Project	CMHA Meadows RAD Renovations	Addendum Number	2
Project Number	18076.04	Date	09/12/2025
To	All Bidders		
<i>This addendum contains changes to the requirements of the bidding Documents, Project Manual and Construction Drawings which have been issued to date. Such changes are to be incorporated into the Construction Documents and shall apply to the work in the same meaning and force as if they had been included in the original documents. Wherever this Addendum modifies a portion of a paragraph of the Project Manual or a portion of any Drawing, the remainder of the paragraph or Drawing shall remain in force.</i>			
General	Clarifications: <i>Bid Form: See attached revised bid form showing line item for permit fee included.</i> <i>Do the gas lines in the laundry room need to be removed? Is the furnace the only gas fed item within the unit?</i> Response: Gas lines are stubbed into the laundry area for future use of a gas appliance. No work is to be done on the gas lines in the laundry room as a part of this renovation. <i>How should the curb be addressed where the sidewalk on the accessible route widens?</i> Response: See Civil drawings updates as a part of this Addendum. <i>Do y

Sheet A105 – OVERALL PLAN - COMMUNITY CENTER

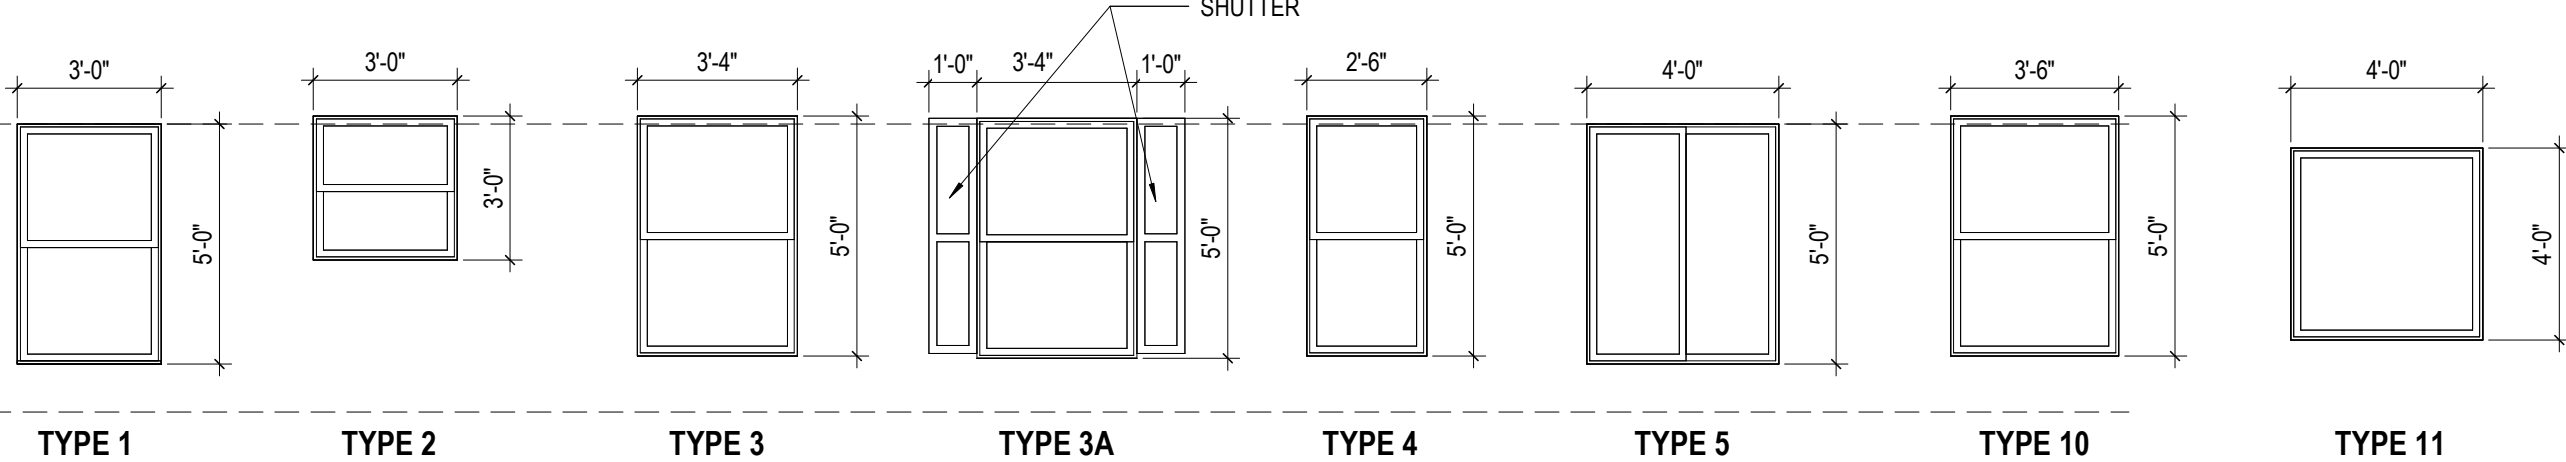
1. DELETED Vestibule from scope of work in Plan 1.
2. DELETED interior partition and Storage Room as clouded in Plan 1.
3. REVISED Coded Note #12.
4. REVISED note 'G' in 'General Notes - Demolition'.
5. ADDED note 'K' in 'General Notes - Demolition'.
6. REVISED 'Elevation Legend' & 'General Notes- Exterior Elevations' to not overlap.

Sheet H900 – HVAC SCHEDULES AND DETAILS

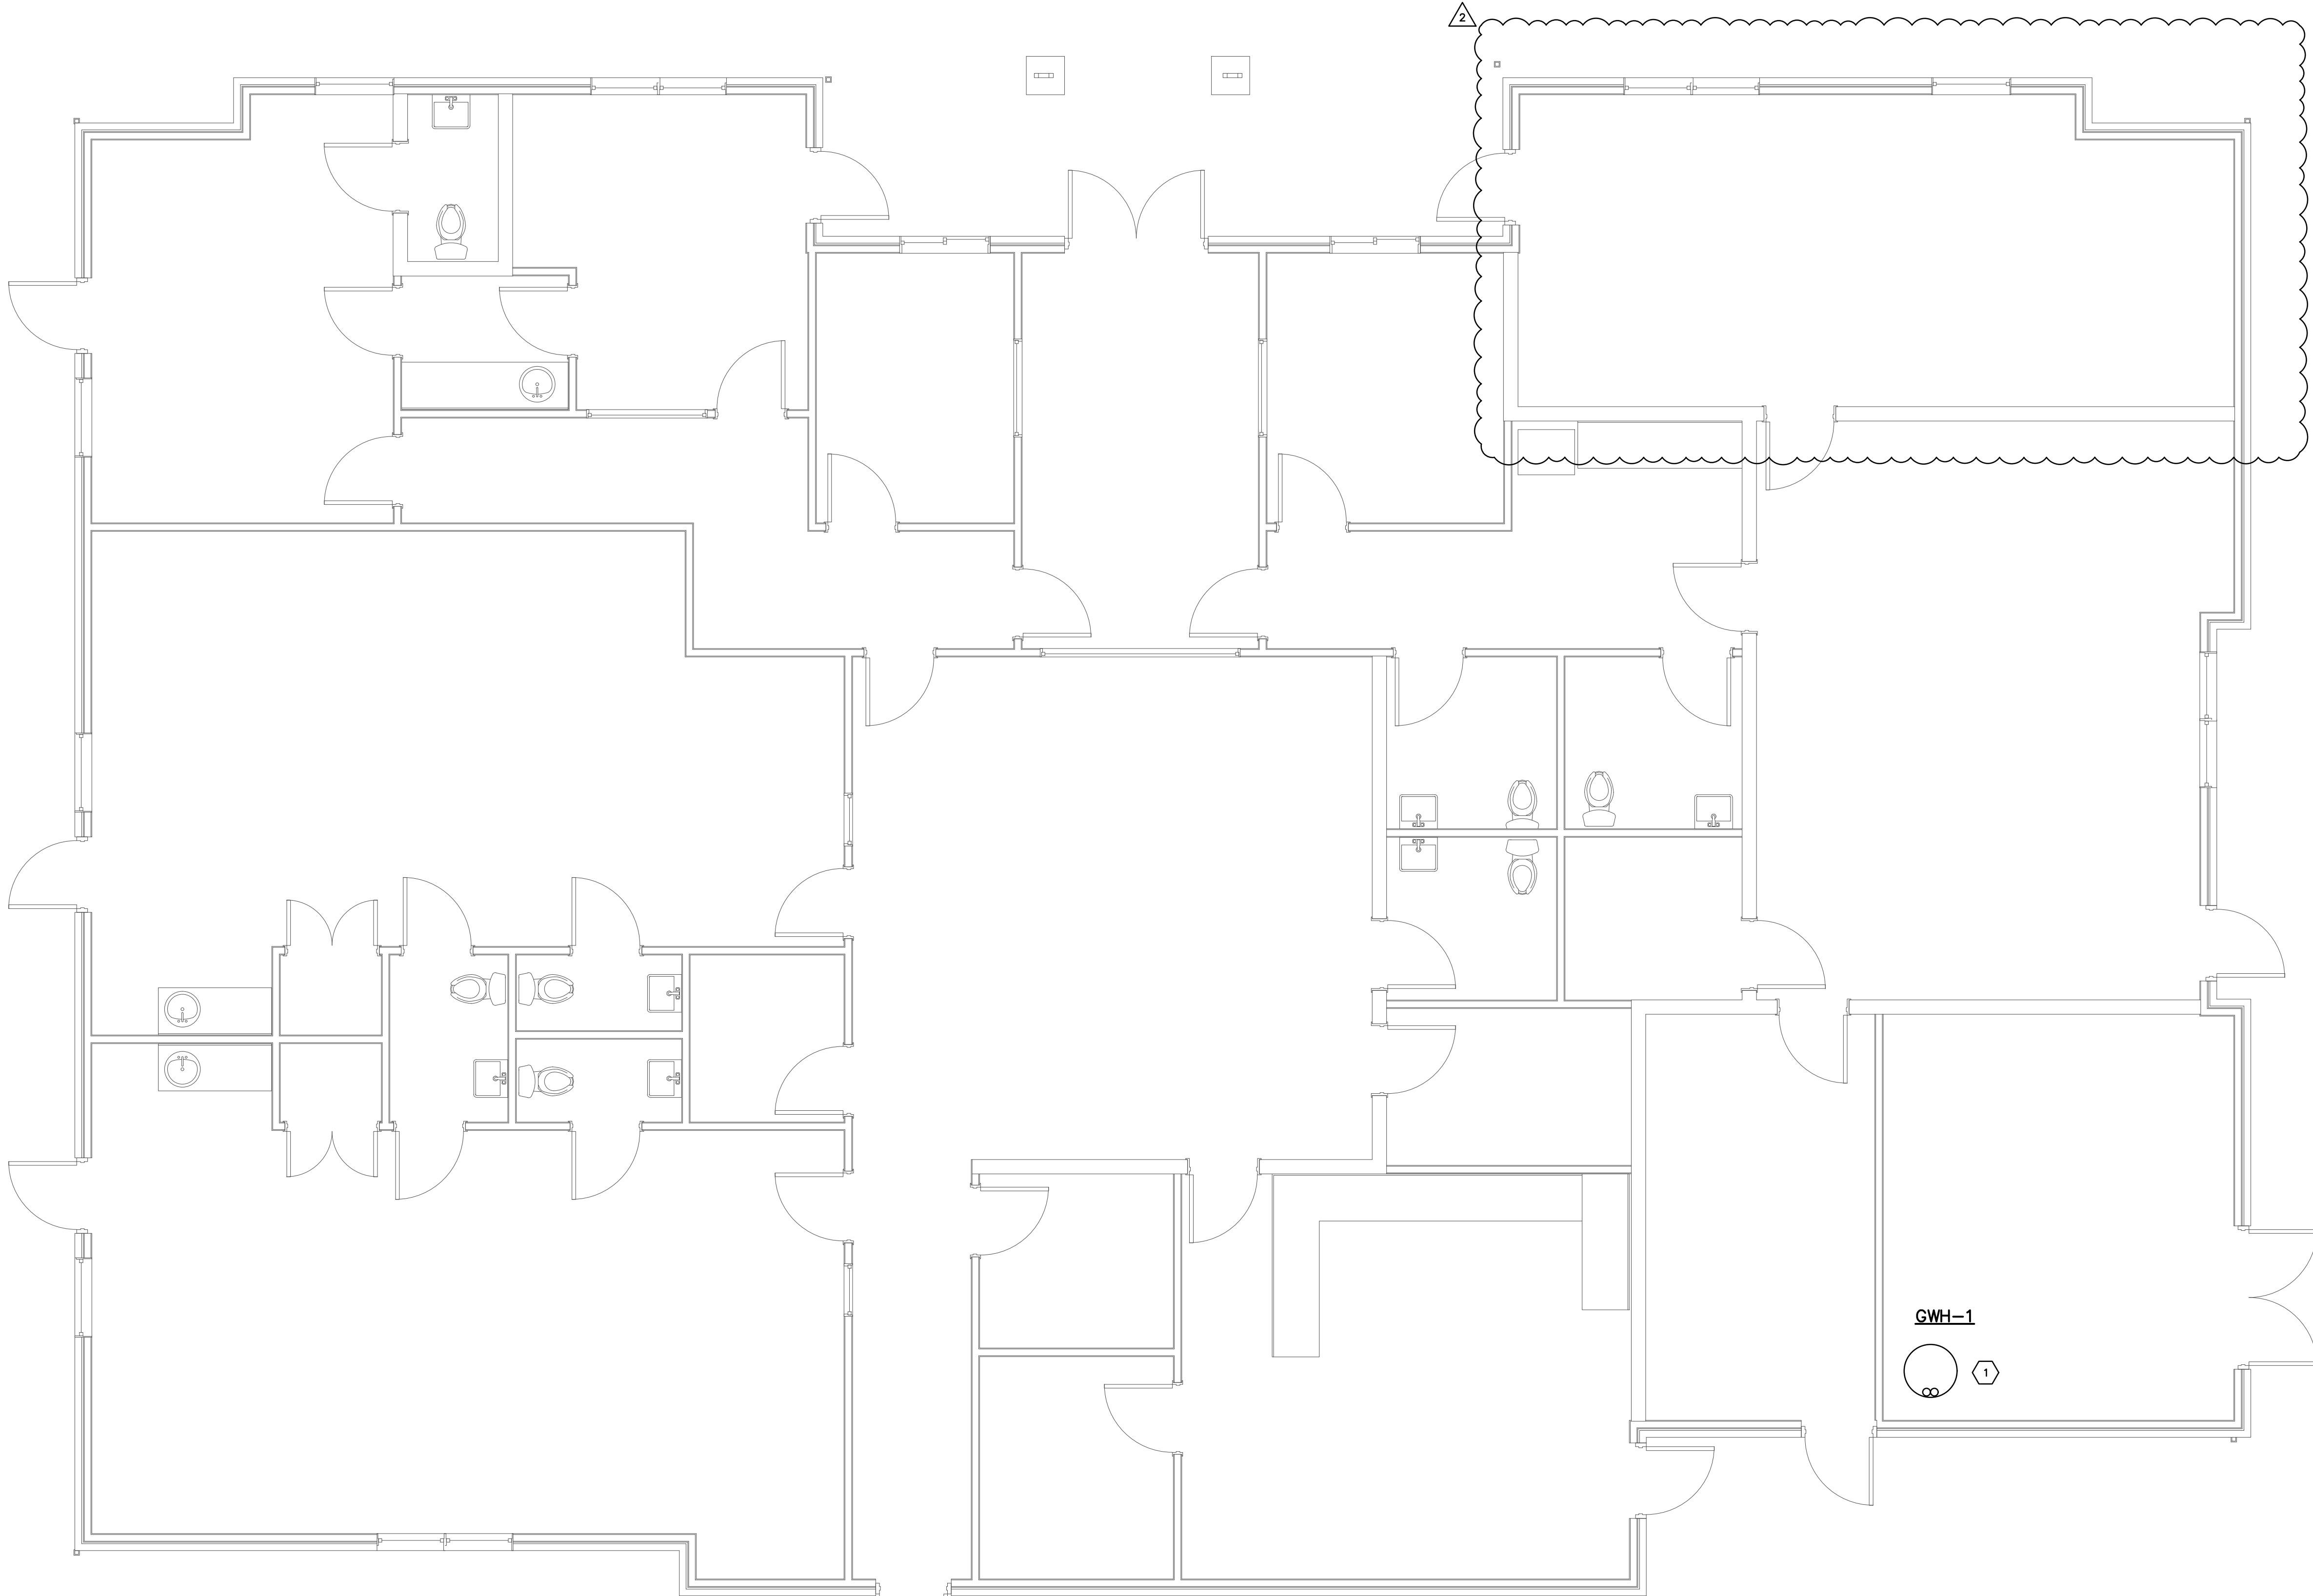
1. ADDED WB-1 washer box to 'Plumbing Fixture Schedule'.
2. REVISED expansion tank note on the 'EWH-1: Electric Water Heater Diagram'.

Sheet H103 – COMMUNITY CENTER MECHANICAL PLANS

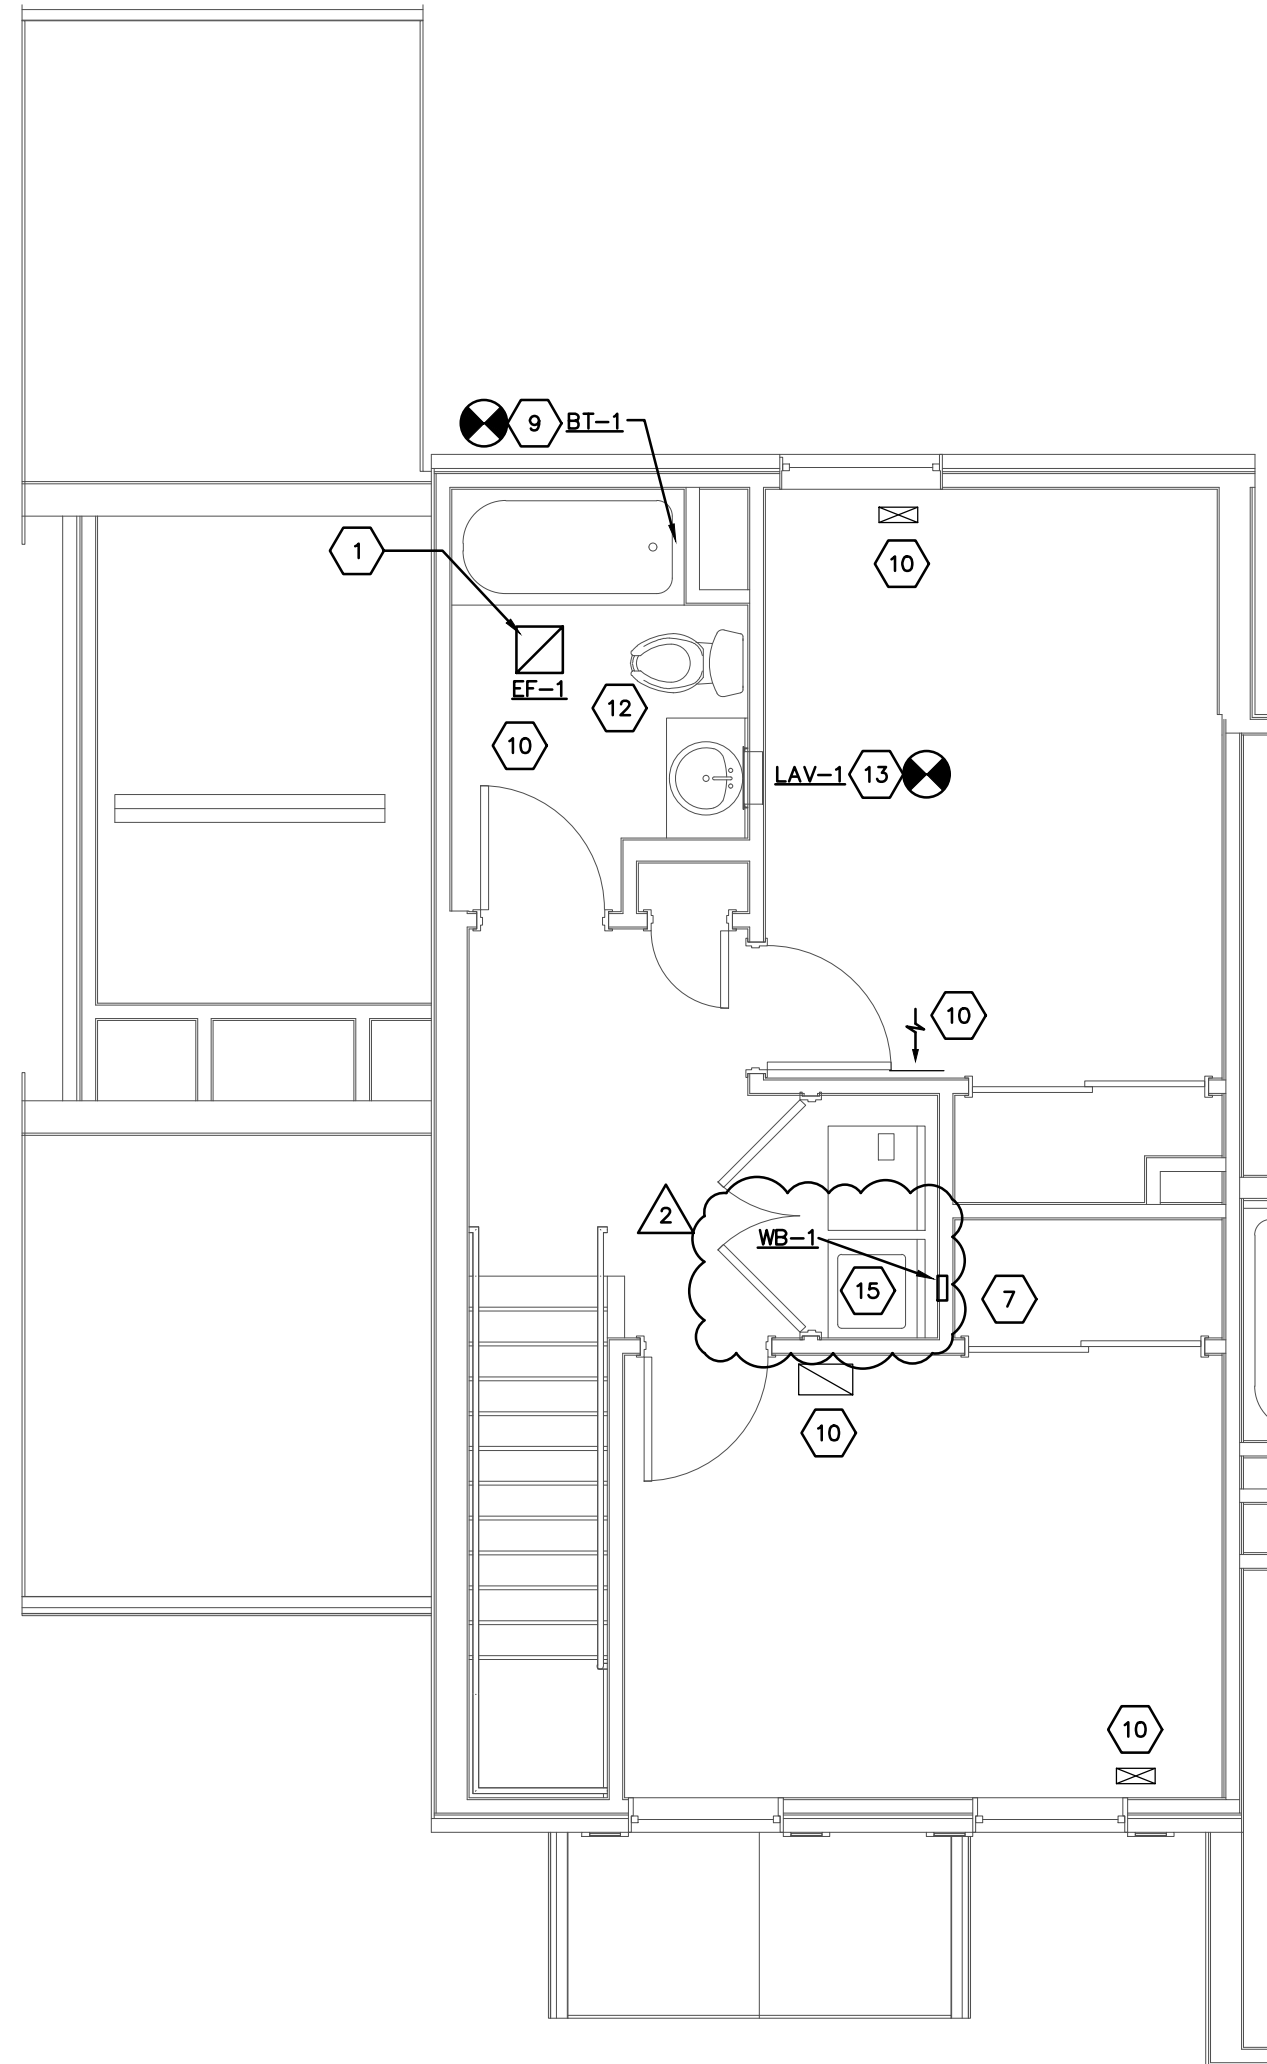
1. Wall was removed, no ductwork rework, removed ductwork.
